Access Compliance Report

Public Rights-of-Way

Intersection ID: 12524	Main Street: W_1ST_ST	Cross Street: S_CHURCH_ST	Location: N
ADA ID: C1472C75B80F	Ramp Type: PerpDiag	Initial Pass/Fail: Fail	Overall Compliance: No
			Severity Score: 26.25

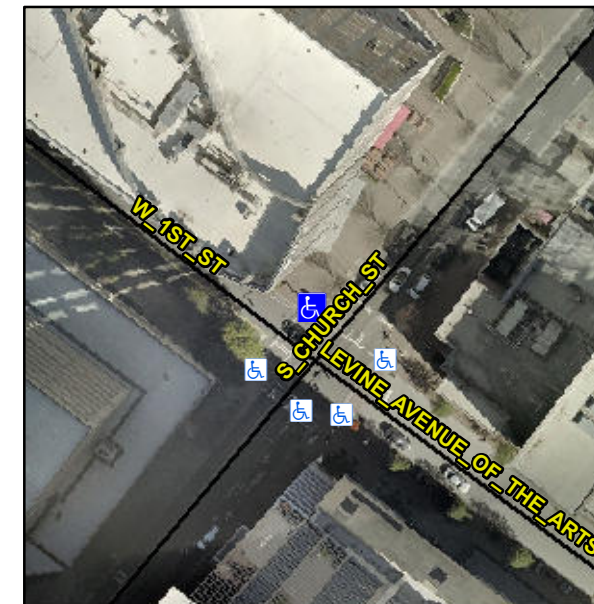
Not Found, R304.2.2

Compliance	Description	Data	Compliance	Description	Data
N/A	Ramp Length (in)	24.0	No	Ramp Slope (%)	12.1
Yes	Ramp Width (in)	82.0	Yes	Ramp XSlope (%)	2.5
N/A	Flare Type LT	N/A	N/A	Flare Type RT	N/A
N/A	Flare Slope LT (%)	N/A	N/A	Flare Slope RT (%)	N/A
N/A	Flare Traversable LT?	N/A	N/A	Flare Traversable RT?	N/A
N/A	Landing Length (in)	N/A	N/A	DWS Provided?	N/A
N/A	Landing Width (in)	N/A	N/A	DWS Contrast?	N/A
N/A	Landing Slope (%)	N/A	N/A	DWS Length (in)	N/A
N/A	Landing X Slope (%)	N/A	N/A	DWS Full Width?	N/A
N/A	Landing Curb? (Y/N)	N/A	N/A	DWS Offset (in)	N/A
N/A	Shared Landing?	N/A			
N/A	Gutter Ponding?	N/A	N/A	Gutter Slope (%)	N/A
N/A	Gutter Lip Ht (in)	N/A	N/A	Gutter X Slope (%)	N/A
N/A	Painted X Walk1?	Yes	N/A	Painted X Walk2?	Yes
	X Walk 1 Direction	To SW		X Walk 2 Direction	To SE
N/A	X Walk 1 Width (in)	110.0	N/A	X Walk 2 Width (in)	83.0
	X Walk 1 Slope (%)	1.1		X Walk 2 Slope (%)	1.6
	X Walk 1 X Slope (%)	4.6		X Walk 2 X Slope (%)	2.1

Remove & Replace Curb Ramp With Two New Directional Ramps or Equivalent.
